WPL8 - Replacing Electric Passenger Compartment Heater (Workshop Campaign)

Model Year: **As of 2020 up to 2023**

Model Line: **Taycan (Y1A / Y1B / Y1C)**

Concerns: **Electric passenger compartment heater**

*Installation position*

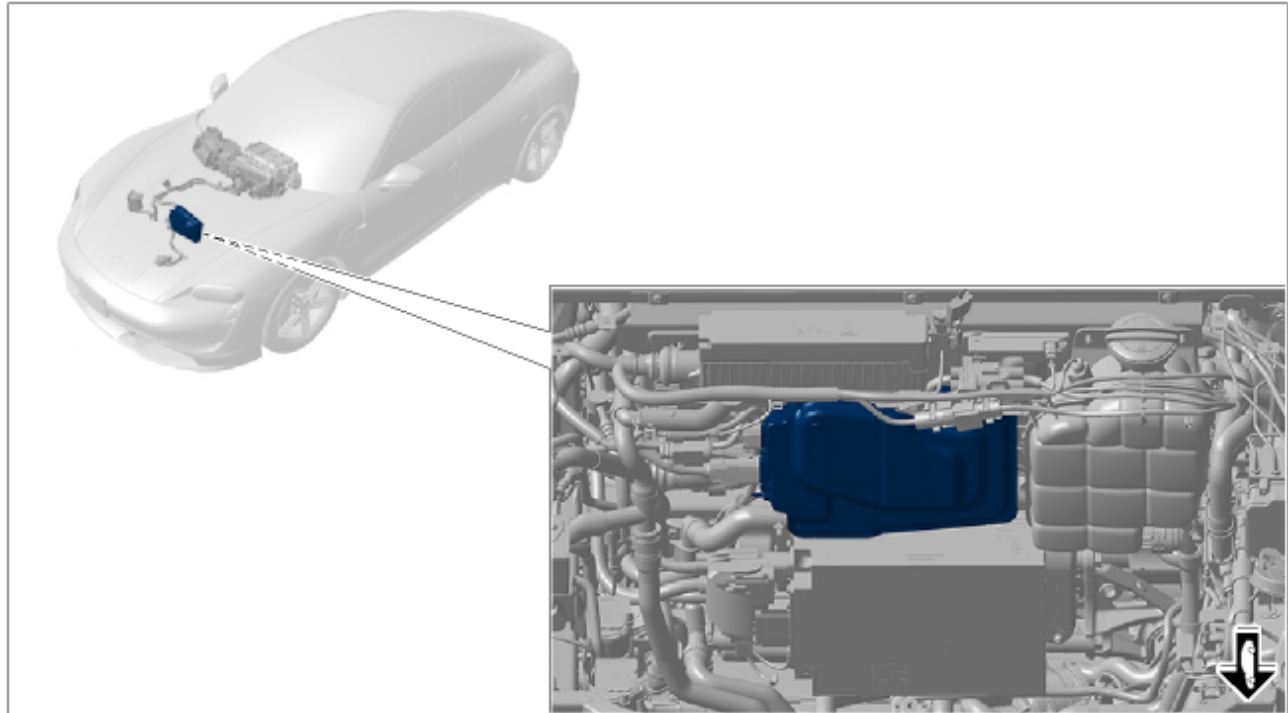
Cause: **Due to a potential material error, the heater coating in the electric passenger compartment heater can become detached on the affected vehicles during prolonged utilization of the heating and with high heating output, especially in countries with frequently cold environmental conditions.**

This may result in the heating function being impaired and the vehicle not defrosting properly when driving.

Action: Replace electric passenger compartment heater.

– (Replacing) **Electric passenger compartment heater**

Electric passenger compartment heater

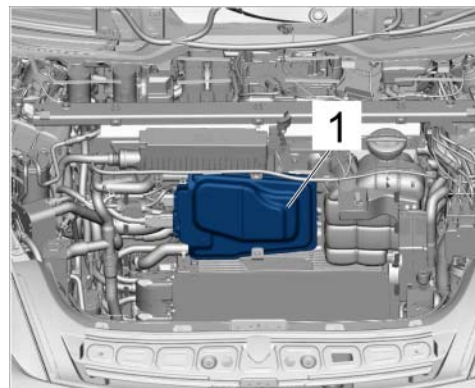
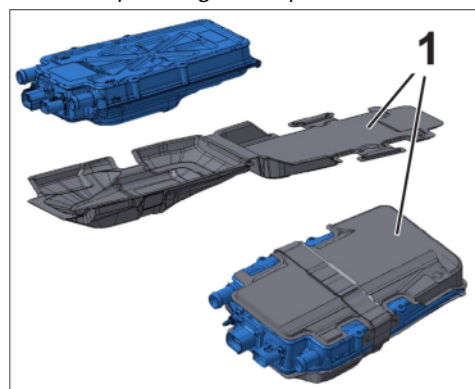
- 2 Remove electric passenger compartment heater ⇒ *Electric passenger compartment heater -1-*.
For this, see ⇒ *Workshop Manual '828019 Removing and installing electric passenger compartment heater'*

Please note that with only vehicles with the **auxiliary heater (M No. 9M3)** equipment option, is a thermal insulation (case) **also** ⇒ *Thermal insulation (case) -1-* installed on the electric passenger compartment heater. This must be converted from the old to the new electric passenger compartment heater.

- 3 Install a **new** electric passenger compartment heater.
For this, see ⇒ *Workshop Manual '828019 Removing and installing electric passenger compartment heater'*
